REPORT AMENDED BY CPC 10-12-89
CITY PLANNING COMMISSION

- APPLICATION:**
- A. Negative Declaration
 - B. Tentative Map to divide 6.7 partially developed acres into 38 standard single family lots in the Standard Single Family (R-1) Zone.
 - C. Variance to reduce the minimum lot depth (withdrawn)
 - D. Subdivision Modification to reduce lot depth (withdrawn)

LOCATION: Northeast Corner of Bellview Avenue and Lemon Hill Avenue

TENTATIVE SUBDIVISION MAP BELLEVIEW ESTATES CITY OF SACRAMENTO JANUARY 1989

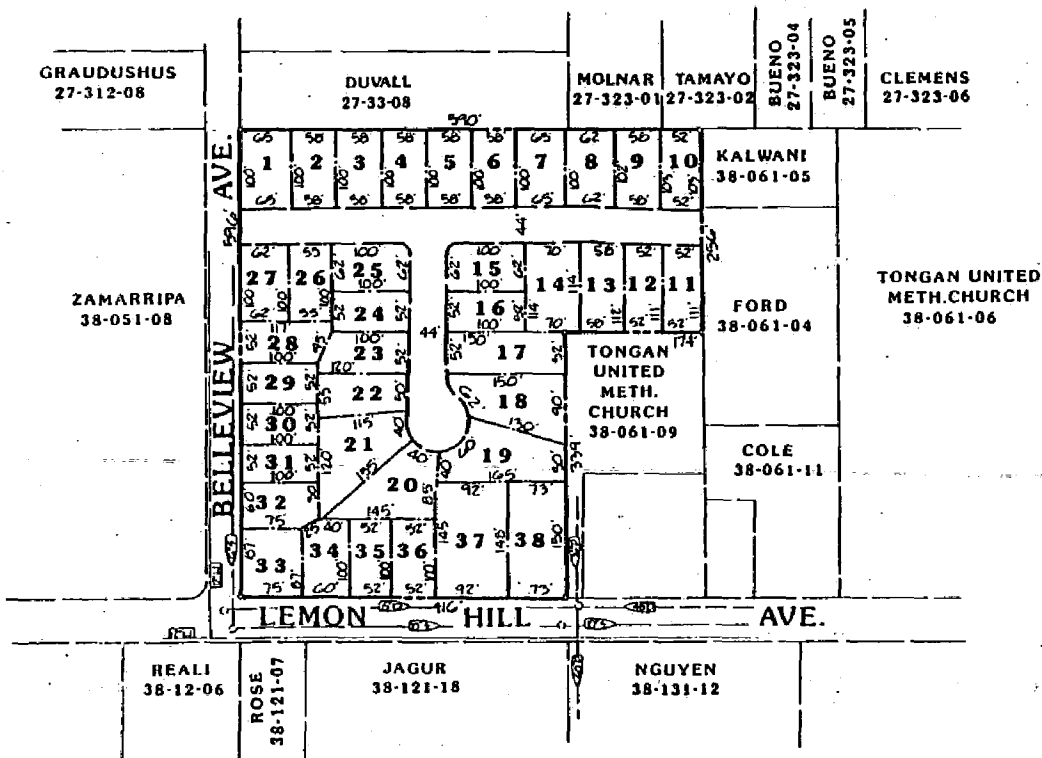
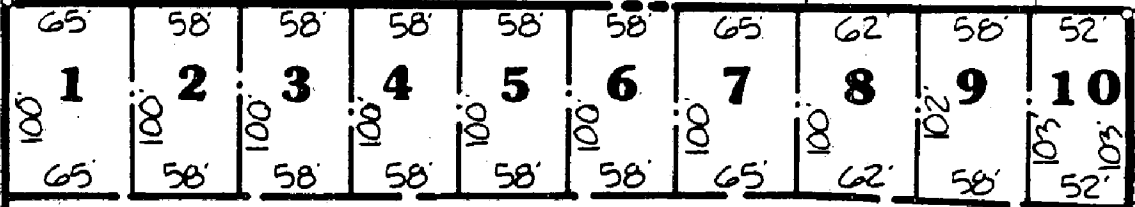
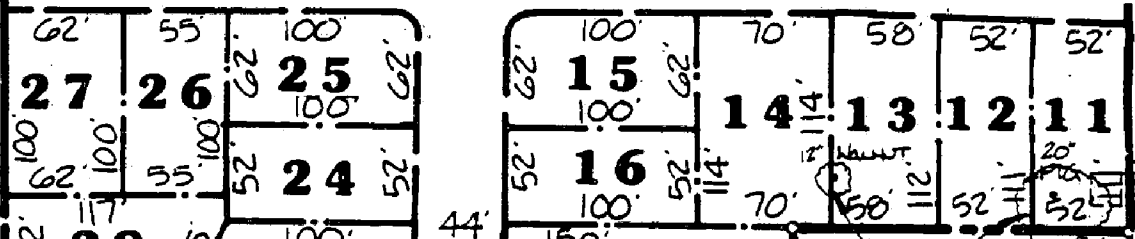
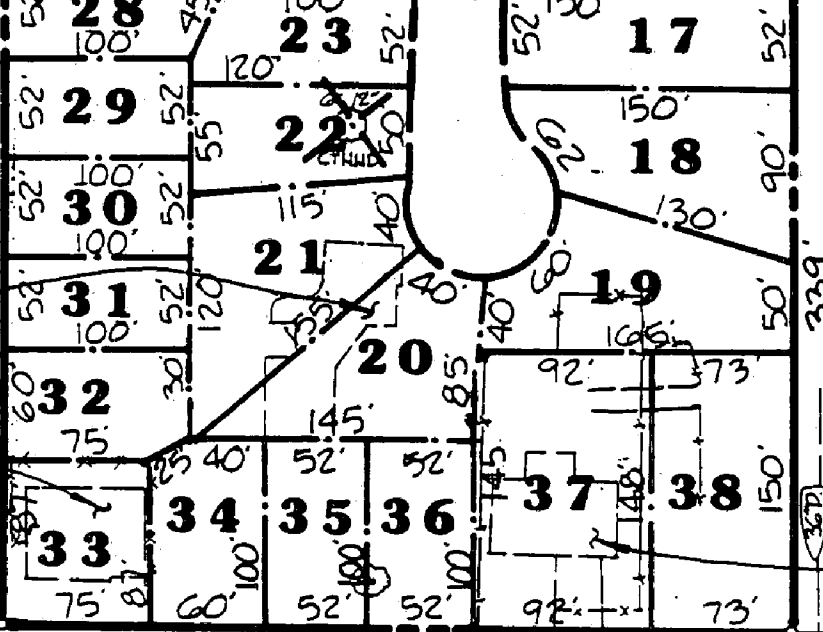
Staff notes that the existing single family dwellings are not shown on the original tentative map. Staff recommends that if the two dwellings are to be retained, that the proposed property lines observe all required setbacks. The final map shall show the existing structures complying with the minimum setbacks of the R-1 Zone.

Staff has noted that a storm drain line easement bisects the site. Lots 14 and 7 and 8 may require redesign to allow for the storm drain easement.

The proposed east-west street off Bellview should have a turning area at the east property line. Staff recommends that the applicant show a turning area approved by the City Traffic Engineer and Fire Marshall's Office.

Three lots fronting on Lemon Hill are 100 feet in depth with two lots 145 feet deep. Staff recommends the lots along Lemon Hill be increased to a minimum of 125 feet of depth and an increased front yard setback established at 35 feet rather than the standard 25 feet. The increased setback would provide a larger front yard commonly found in the area. Lot width should be increased to a minimum width of 60+ feet which is less than the 75 foot development standards along major streets stated in the 1986 South Sacramento Community Plan.

In reviewing the tentative map design, staff observes the mix of lot dimensions makes for several oddly shaped parcels. Staff recommends that the applicant redesign the tentative map to show more standard parcels reflecting easements, buildings to be preserved, and standard size lots on the interior and lots 125 feet deep and 58+ feet in width fronting on Lemon Hill.

14. Place flood hazard warning note on final map, if required. Note will be provided by Department of Public Works;
15. Revise the lots along Lemon Hill to be a minimum of 60+ ft. in width and 125 feet in depth. A minimum 35 foot front yard setback shall be recorded for all lots fronting on Lemon Hill;

16. Future property lines shall observe the minimum required setbacks from all existing structures. The final map shall show existing structures and dimensions to all property lines;

18. Show all existing storm drain locations and existing ditches on the final map;
19. Show Bellview with a 50 ft. R/W (25' half-section) and standard round corner on lots 1, 27, and 33;

20. Preserve trees as shown on the tentative map;
21. Provide a temporary turning area at the eastern end of the proposed east-west street off Bellview to the satisfaction of City Traffic Engineer;

DRAFT
 REVISED TENTATIVE
 MAP 7-26-89
 BELLEVIEW ESTATES.

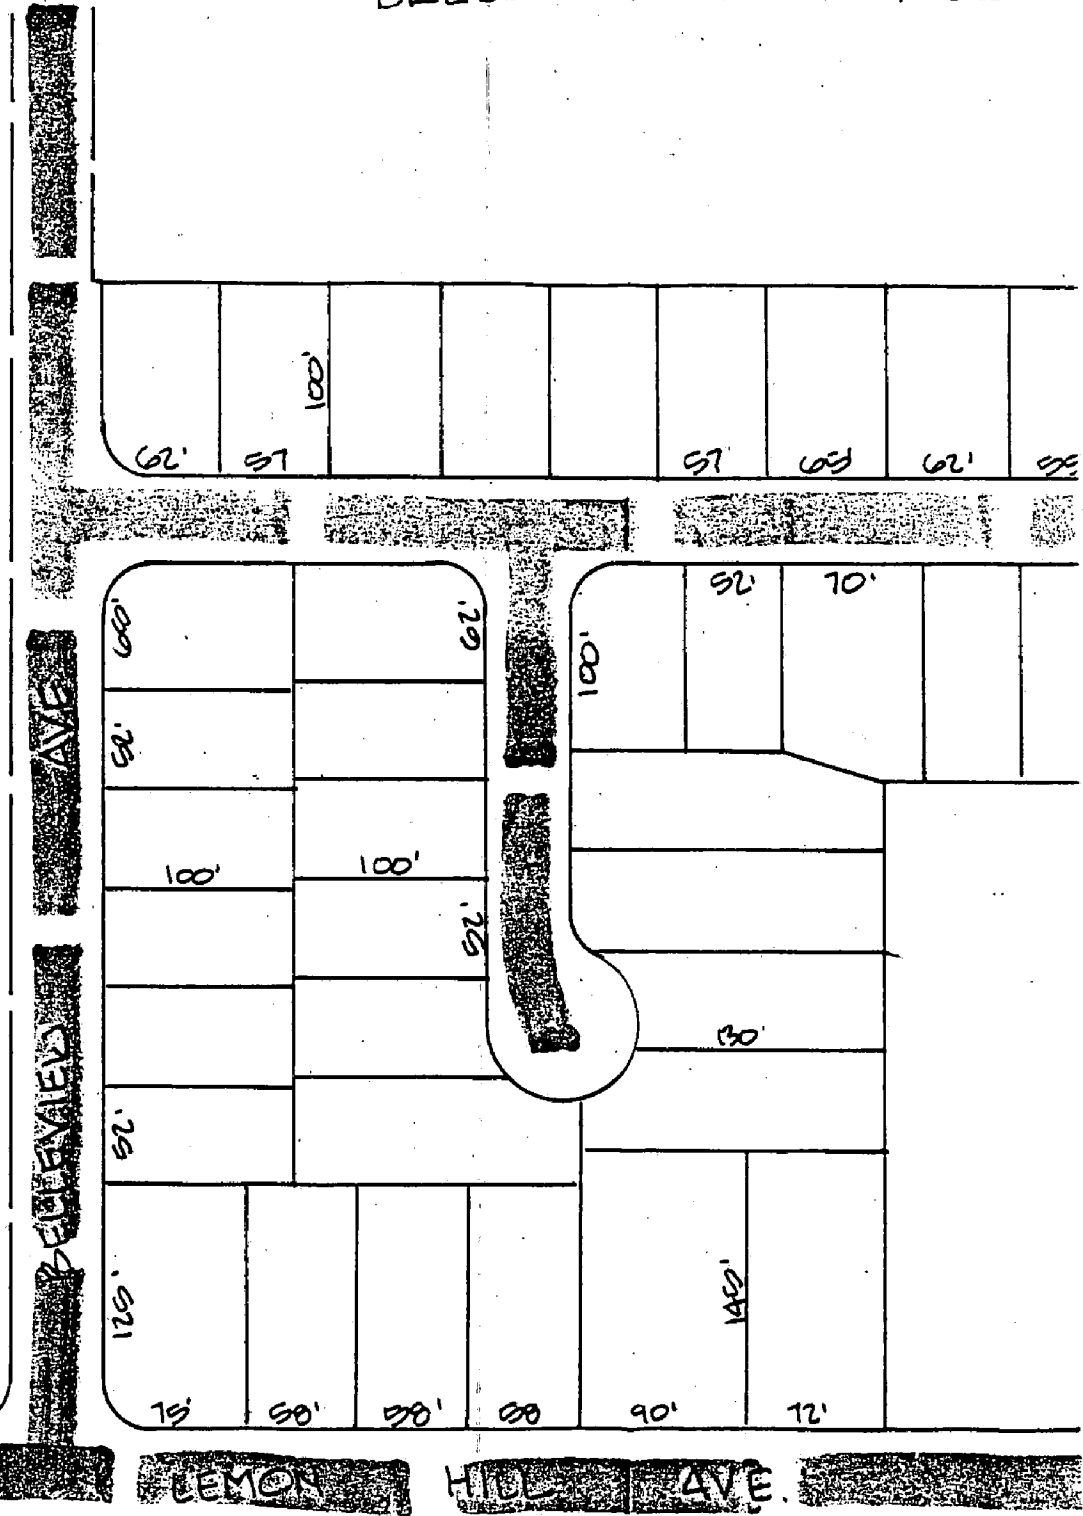
The applicant provided a revised map at the July 26, 1989, Subdivision Review Committee meeting which increased the lot depth of parcels fronting on Lemon Hill from 100 feet to 125 feet. Specific setbacks from the proposed property lines to be existing dwellings were not shown. Staff recommends that actual property lines reflect minimum building setbacks.

Storm drain line easement

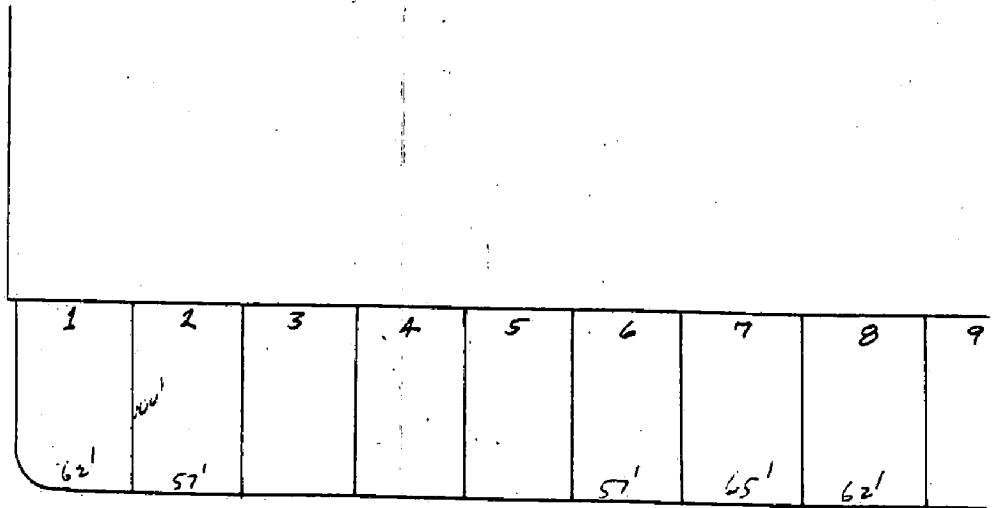
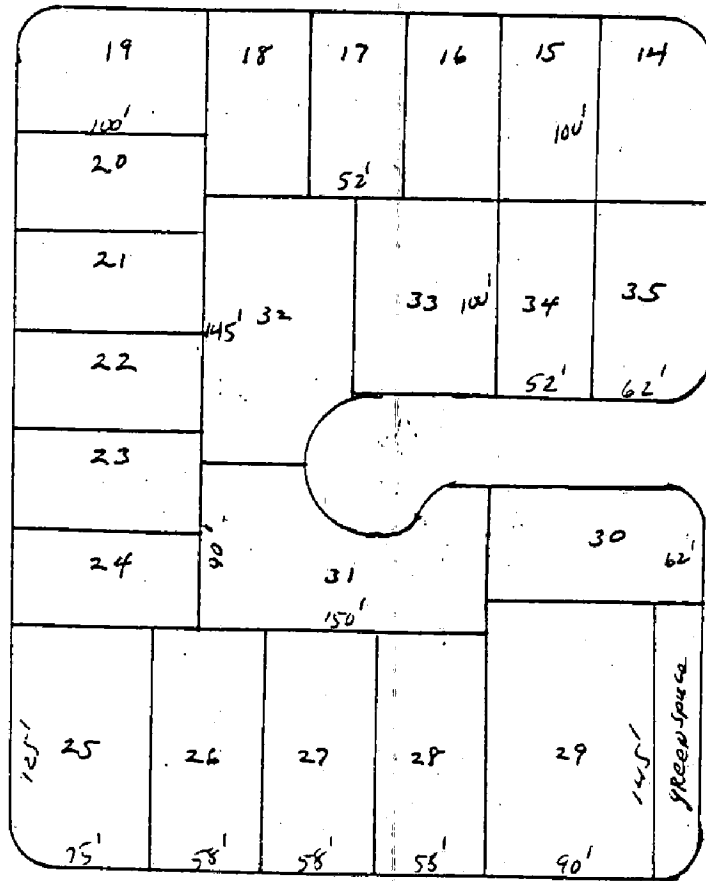
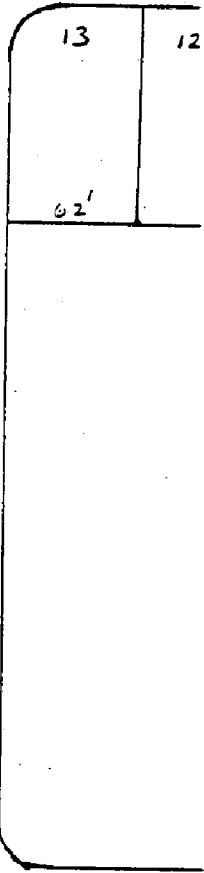
Belleview can just barely handle the present automobile traffic. Fact, there are at least 30 new homes presently being constructed further north on Belleview. This will increase traffic by at least 30%. The tentative plan before you diverts all its new traffic on to Belleview, another 30+% increase in traffic. The present residents on Belleview want a **SECONDARY ACCESS TO THE DEVELOPMENT**, now and not in some imaginary future. This will **reduce the hazards** presented by the automobiles on this street which after construction will for the most part still be a rural road, not quit large enough in places for two cars to pass without driving off the pavement. There are plans here to line the pockets of developers but not enough planning to resolve all the down stream problems for the community. Mr. Johnson said he was good at planning and could do just about anything to meet needs. I believe him and ask why a second access to Lemon Hill is not possible? I have provided some quickly sketched possible solutions Exhibit #1 & #2. I am sure they could be manipulated by a good planner to maximize benefits.

4. The other major concern is with the development fitting in to the existing neighborhood. Present property fronts are on average 100 feet. We are requesting that those properties fronting on Belleview be **MORE APPROPRIATELY SIZED** to blend into the neighborhood rather than stick out, as is exemplified on Exhibit #1 (approx. 80 foot fronts).
